工程指示 / 要求簡箋(E.I.)

工程指示編號：EI / 0216 / 19

工程名稱：觀塘裕民坊

工程項目：幕牆 副框及玻璃線 (T3)(大貨 10-25,29-50/F)

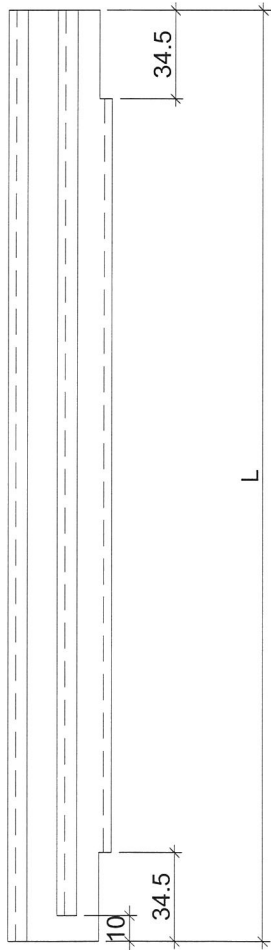
塗黑部分避位去水缺口

塗黑部分避位

生窗死牆位頂用

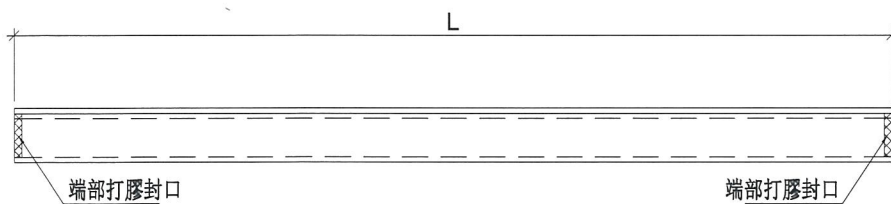
依據10067 C版修改
單插線, 開 ϕ 5去水孔

梗窗死牆位底用

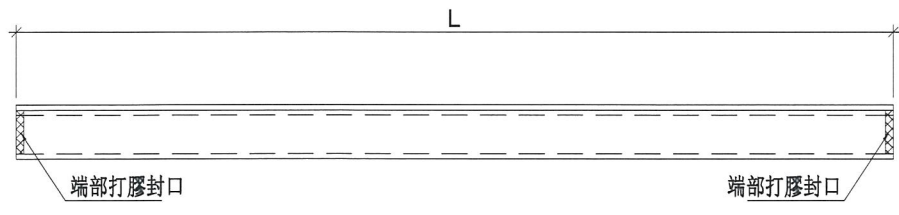
依據10067 C版修改
單插線, 開 $\phi 5$ 去水孔

SD頂死牆位頂用

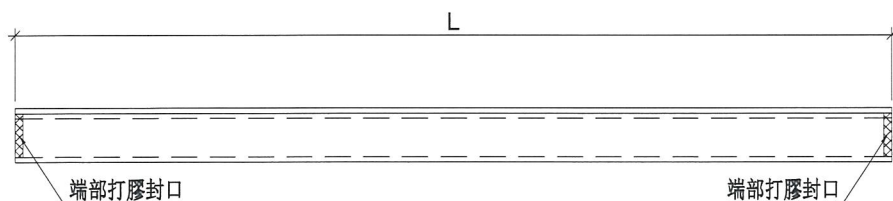
依據10067 C版修改
單插線, 開 ϕ 5去水孔

SHL生窗死牆位二合一底用

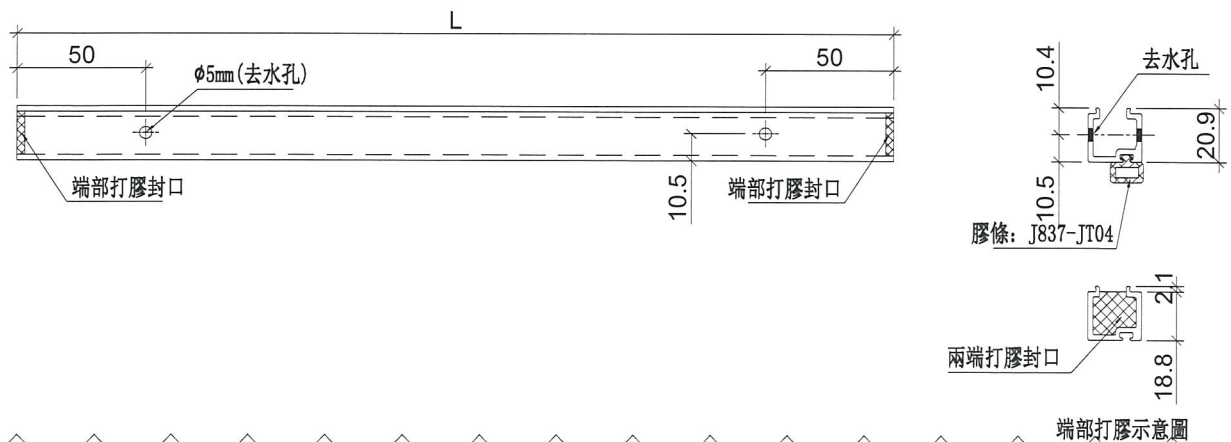
依據10067 C版修改
單插線, 開 $\phi 5$ 去水孔

SHR生窗死牆位二合一底用

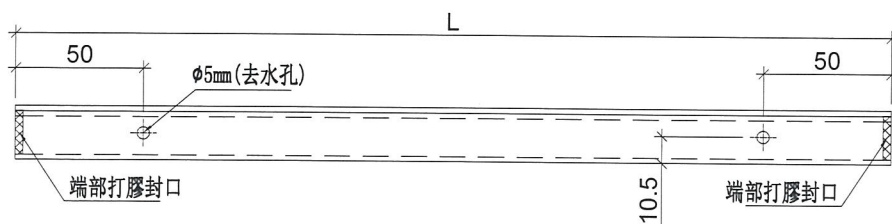
依據10067 C版修改
單插線, 開 $\phi 5$ 去水孔

梗窗死牆位二合一底用

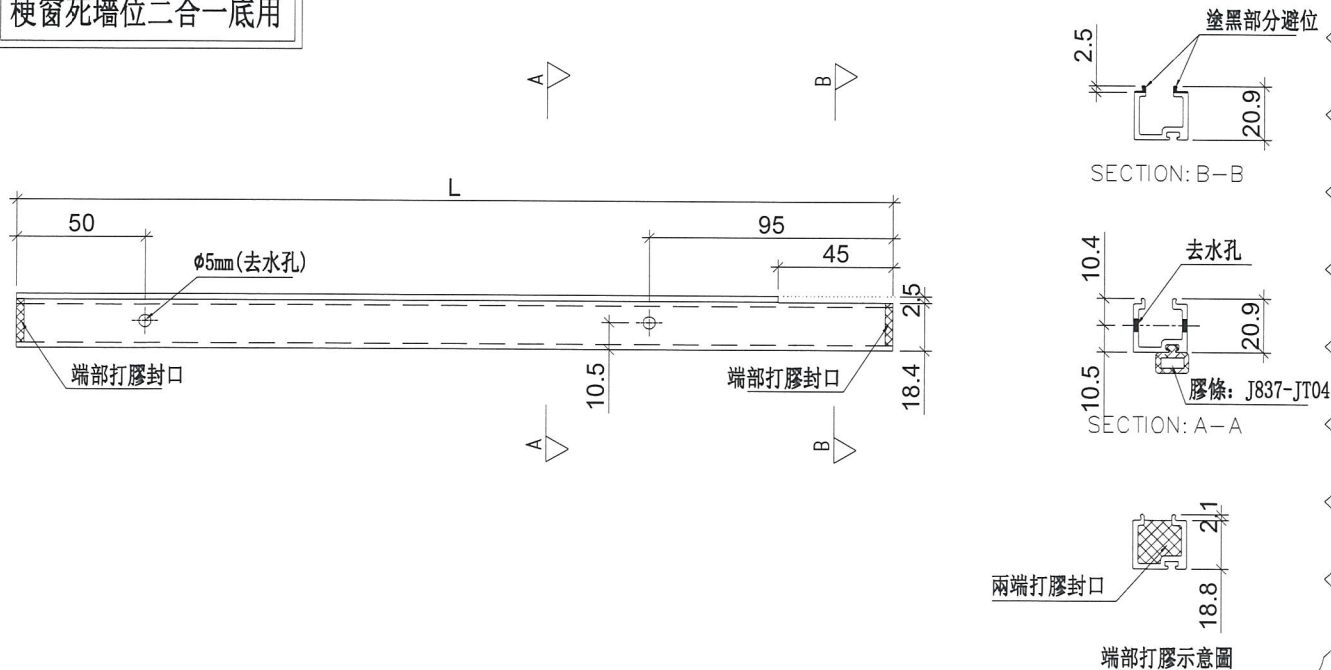
依據10067 C版修改
單插線, 開 $\phi 5$ 去水孔

梗窗死牆位二合一底用

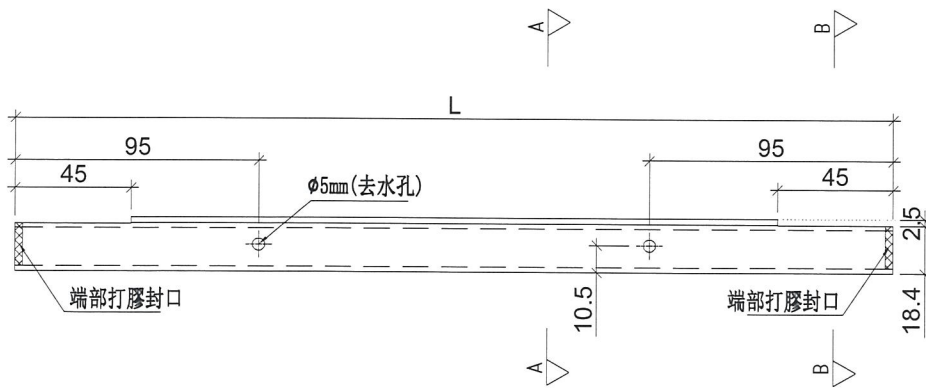
依據10067 C版修改
單插線, 開 $\phi 5$ 去水孔

生窗死牆位底用

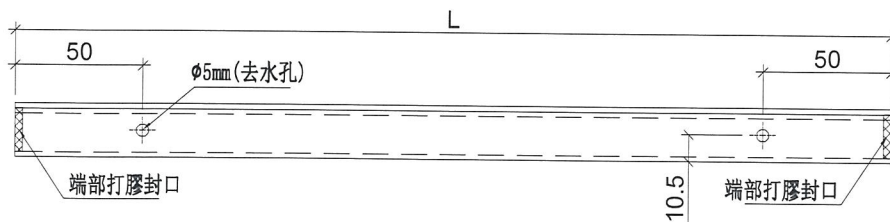
依據10067 C版修改
單插線, 開 $\phi 5$ 去水孔

新增

梗窗死牆位底用

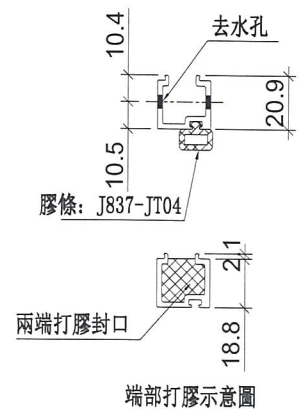
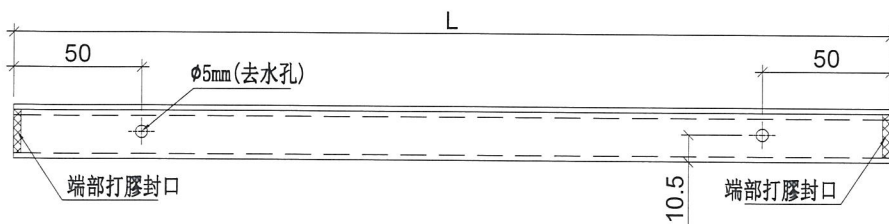
依據10067 C版修改
單插線, 開 $\phi 5$ 去水孔

新增

SD頂死牆位底用

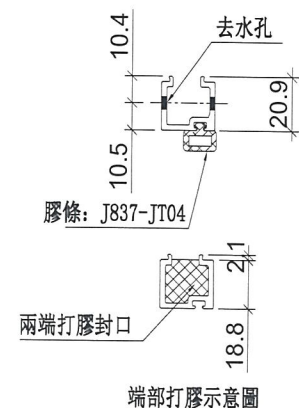
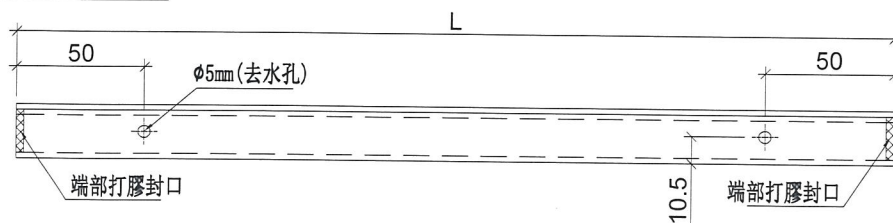
依據10067 C版修改
單插線, 開 $\phi 5$ 去水孔

新增

SD死牆底吊船位用

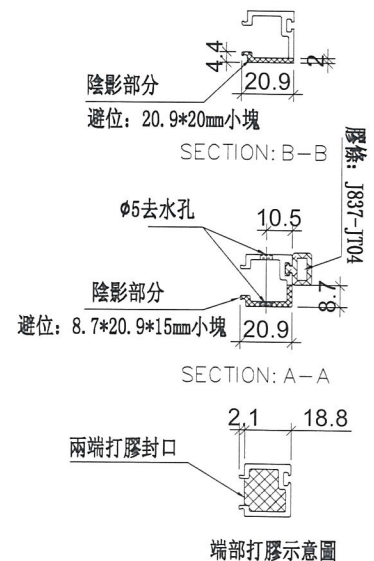
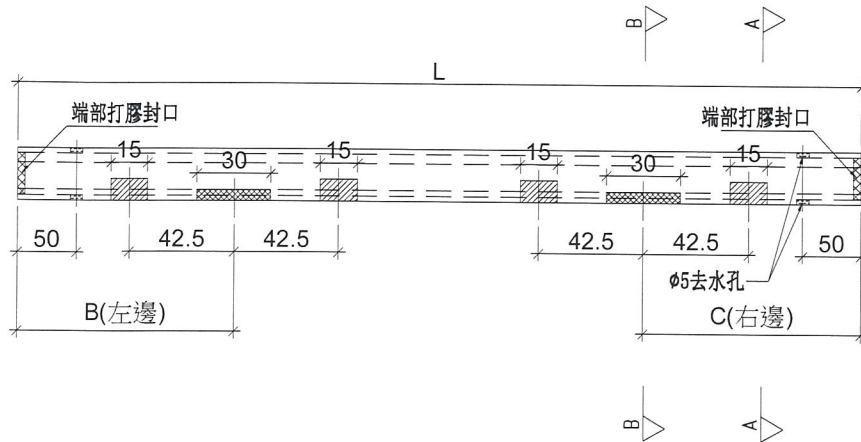
依據10067 C版修改
單插線, 開 $\phi 5$ 去水孔

新增
